RE: CHPE LLC
OE Docket No. PP-481
Supplement to Pending Application of CHPE LLC
to Amend Presidential Permit No. 481

SUPPLEMENT TO PENDING APPLICATION OF CHPE LLC
TO AMEND PRESIDENTIAL PERMIT NO. 481

APPENDIX A
REVISED TYPICAL TRENCH DETAIL
FOR HVAC CONFIGURATION

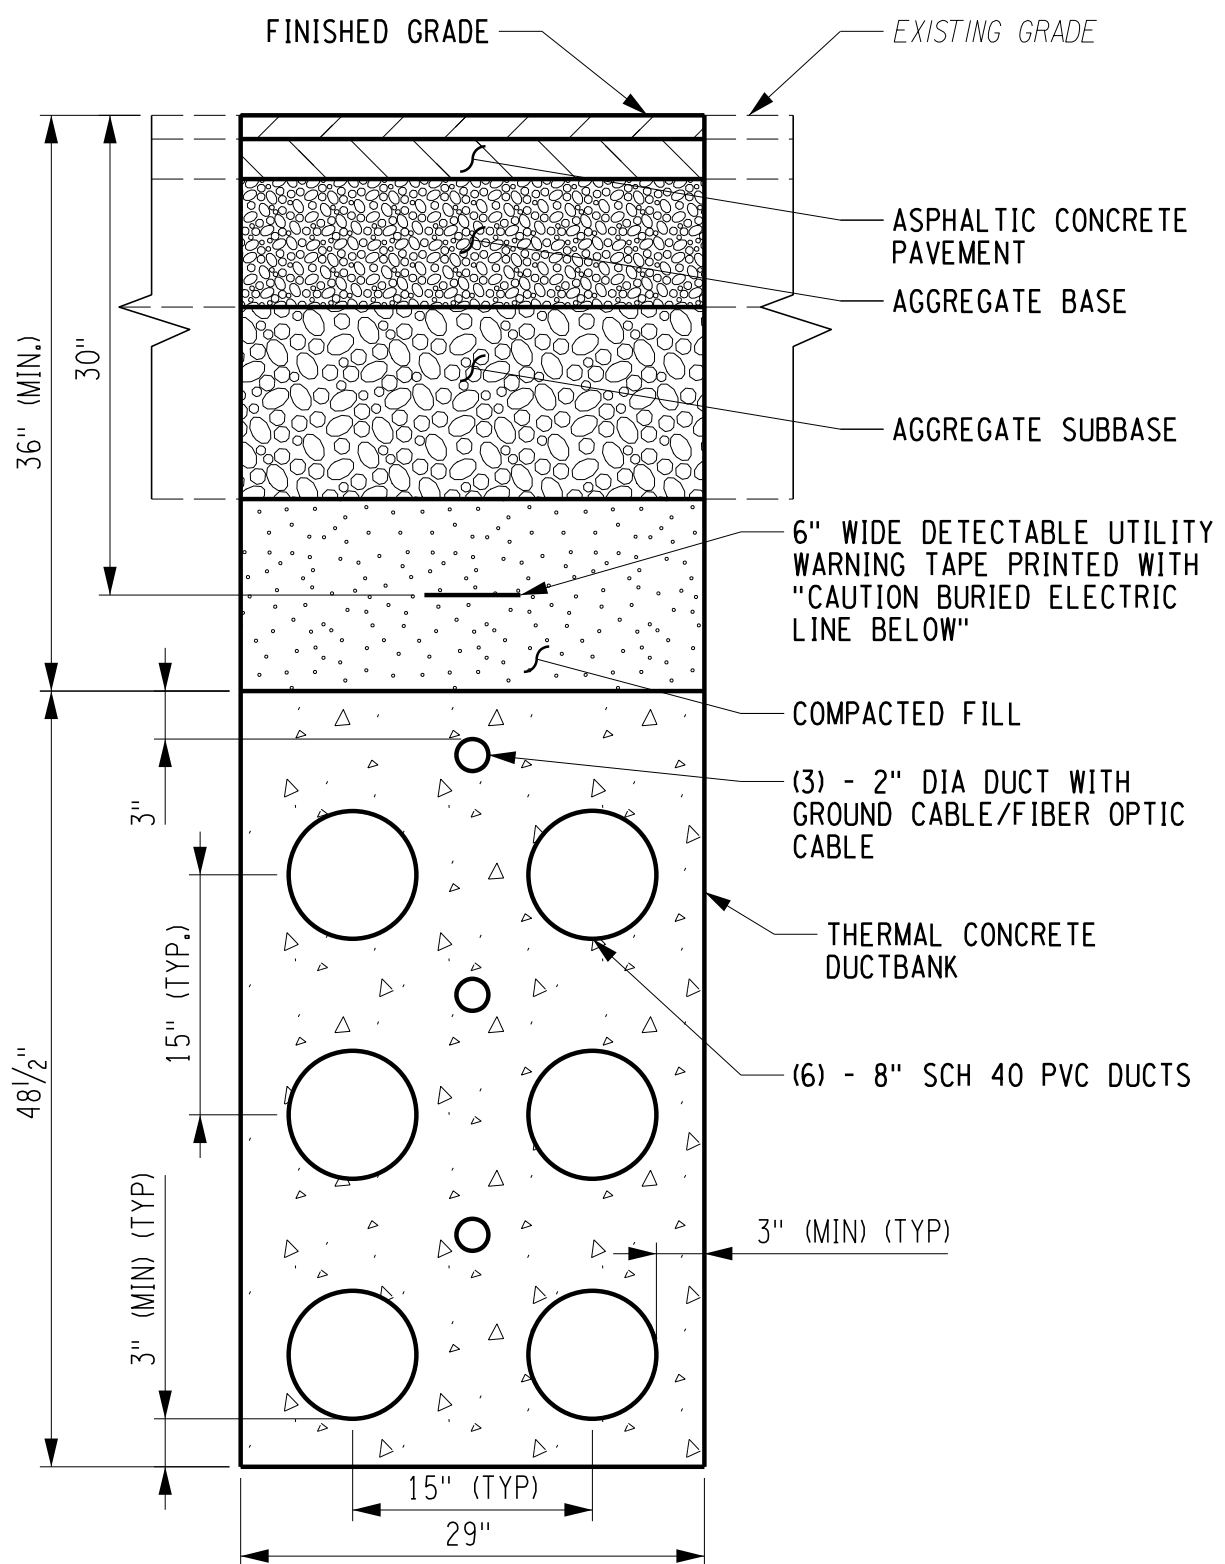
HVAC cables extending from the Astoria East substation to the Rainey substation will be installed using techniques that remain unchanged from those described in the Project Documentation. To accommodate the additional 250 MW, the design of this HVAC system has been altered such that there are now two conductors per phase proposed instead of one conductor per phase. The outcome of this change is a different configuration of the AC system underground, but no changes above ground. A typical diagram showing the new HVAC configuration is included as Appendix A.
